From: McIntosh Perry Consulting Engineers

Date: June 15, 2021

Re: Review of Geotechnical Report upon Changes in Site Plan, 2830 Carling Ave. and 810 Vick Ave.,
Ottawa, Ontario

This memorandum intends to address comments regarding the applicability of “2830 Carling Ave. and 810 Vick Ave. Geotechnical Report” (the Report), to the updated Site Plan as indicated in the Site Plan Control Application Comments issued by the City of Ottawa “the City”, File No. D07-12-20-0163.

**APPENDIX B
NEW SITE PLAN**

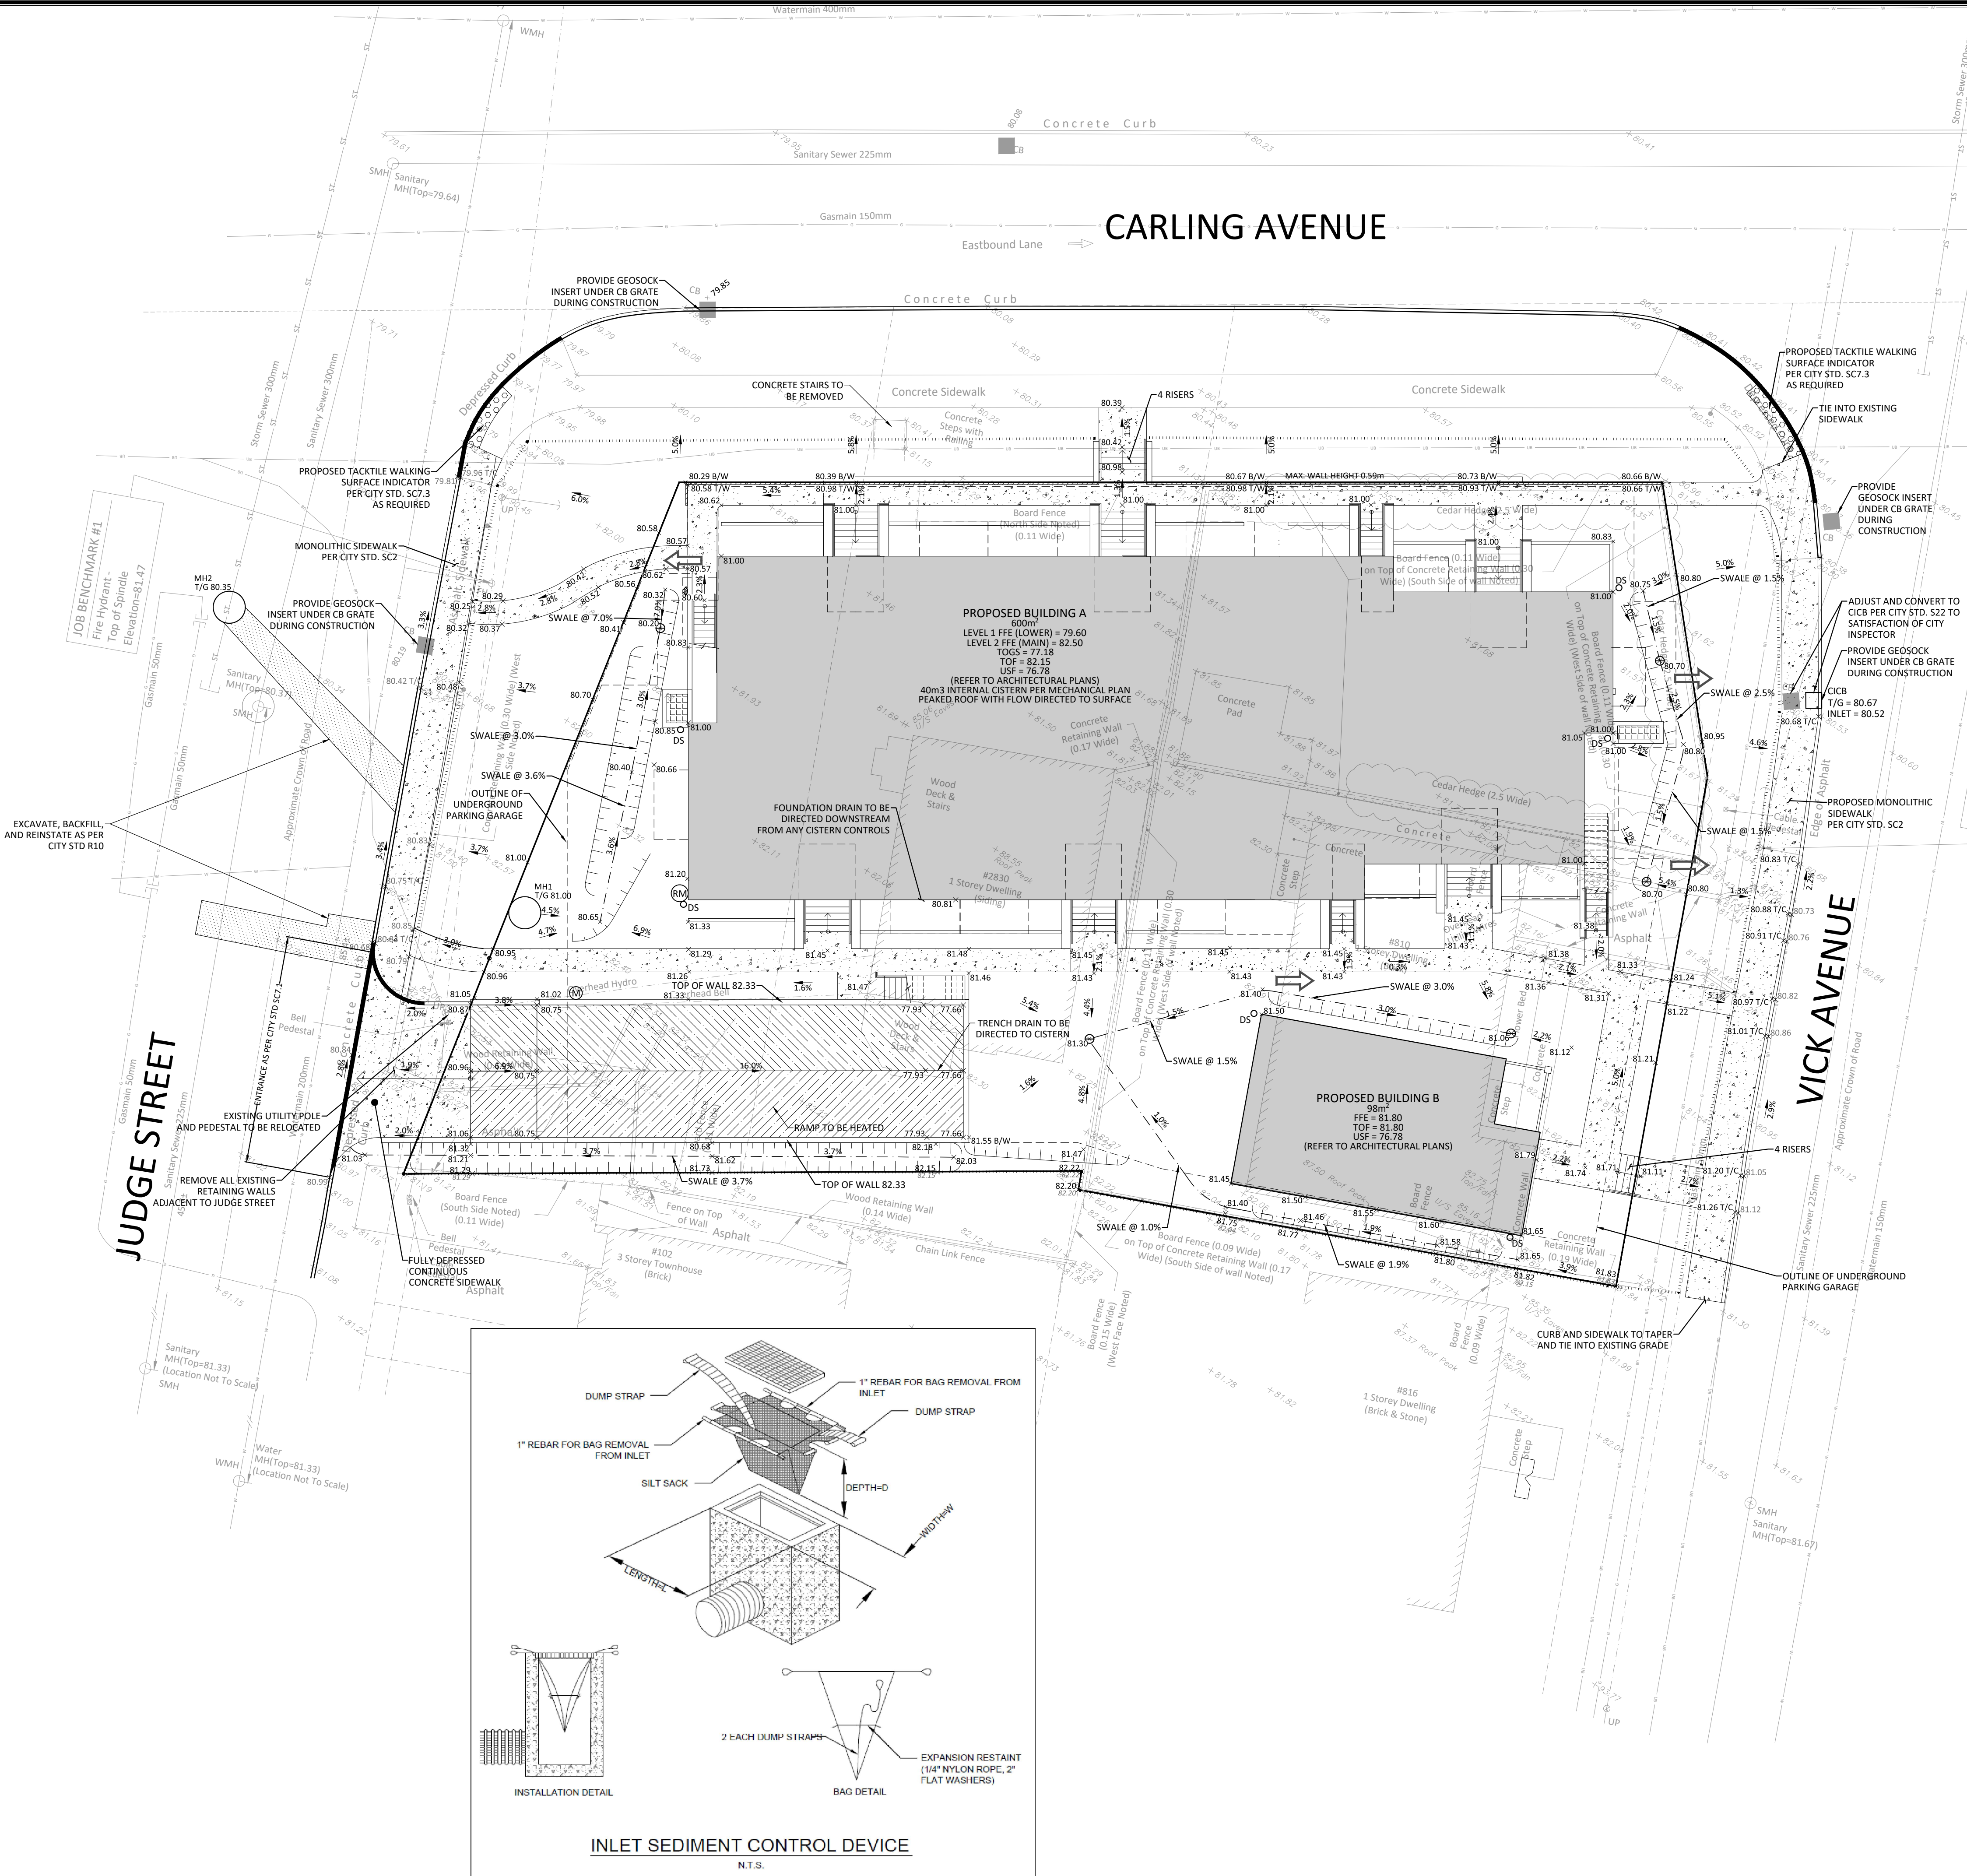
Based on the provided new site plan for the project, the new site plan is similar to the former site plan with few exceptions. The most noticeable difference is that there is an approximate difference of 1.32 m in the underground garage slab level. As mentioned in the Report, the underground garage slab level in the former site plan was approximately El. 78.5 m while in the new site plan the finish slab level is at El. 77.18 m. This change may have effects on:

- **Bearing Resistance:** The estimated geotechnical resistance values for the former site plan were given for shallow footings of a minimum width of 1.5 m supported on the underneath sand at an approximate elevation of 78 m to 77.5 m. The mechanical properties of the sand layer were derived from SPT field test and were used to estimate the geotechnical resistance. The proposed foundation level in the new site plan is 76.78 m. Based on the presented data of the SPT test, the SPT 'N' values below the new foundation level within the influence zone do not drop. Therefore, the shear strength parameters that were derived from SPT are still valid. Therefore, recommendations given in section "7.5.1 Shallow Foundations" for foundation design are still applicable.

- **Lateral Earth Pressure:** There will be an increase in the lateral earth pressure on the underground garage walls which needs to be addressed in the structural design. Also, the designer of the lateral support "shoring" system that is required for excavation and construction needs to consider the increase in the lateral earth pressure due to the change in the final level of the underground garage. The provided lateral earth pressure coefficients in Section "7.9 Lateral Earth Pressure" in the Report are still valid for the purpose of determining the lateral earth pressure and shoring system design.

In conclusion, we believe that the "2830 Carling Ave. and 810 Vick Ave. Geotechnical Report" is still valid with respect to the new site plan, presented in Appendix B. This memo should be read in conjunction with "2830 Carling Ave. and 810 Vick Ave. Geotechnical Report". The recommendations presented herein are subject to the limitations noted in Appendix A "Limitations of Report" which forms an integral part of this document.
